# CrossRoads RV

## SAFETY ADVISORY # 16-254 Outside Kitchen Seal

CrossRoads RV is conducting a voluntary RECALL notification campaign in accordance with the National Highway Transportation and Safety Act. It has been decided the vehicles in this recall population may have been manufactured with an opening between the inside and outside kitchens. Because of this condition the range burner flame may be extinguished when the exterior kitchen door is opened. Continued propane flow, in the presence of an ignition source, could result in a fire and/or explosion causing property damage and/or personal injury.

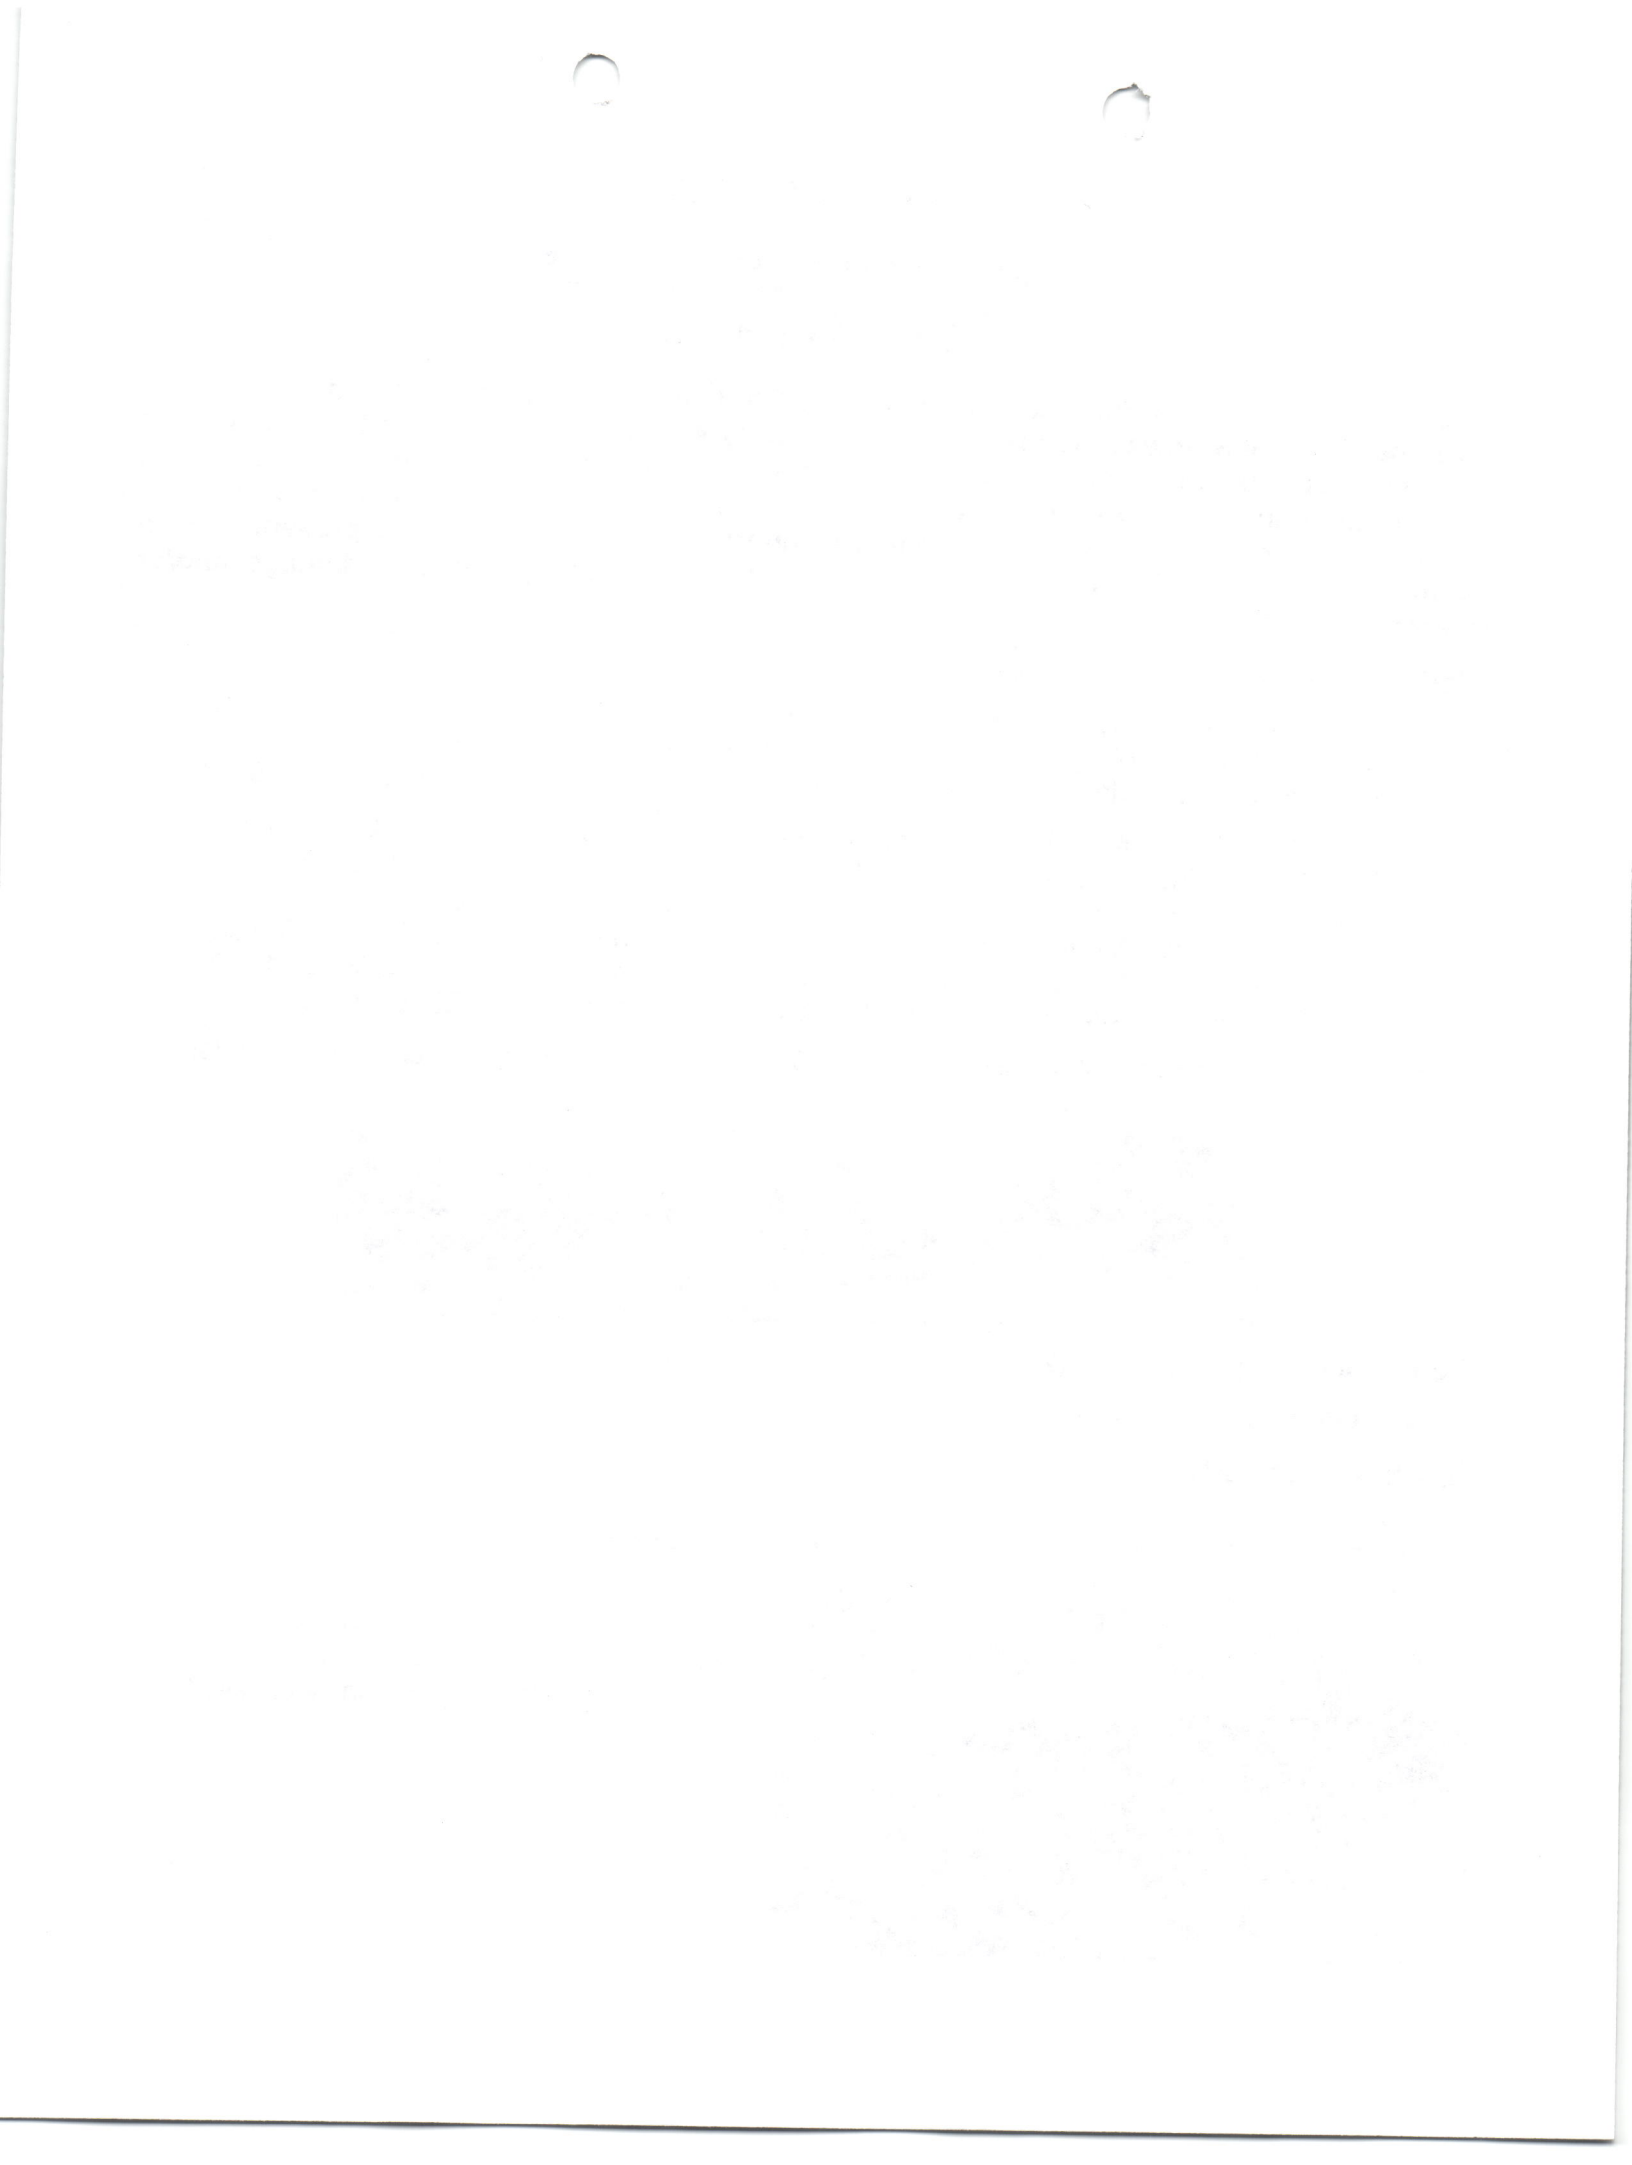
Open the outside kitchen and locate the opening to be covered by looking up. There should be a visible cleat that the screws can be installed into, Fig. 2.

Mark the cleat location on the supplied stile, and start the screws.

Insert the stile and fasten into place.

Seal any gaps with silicone.
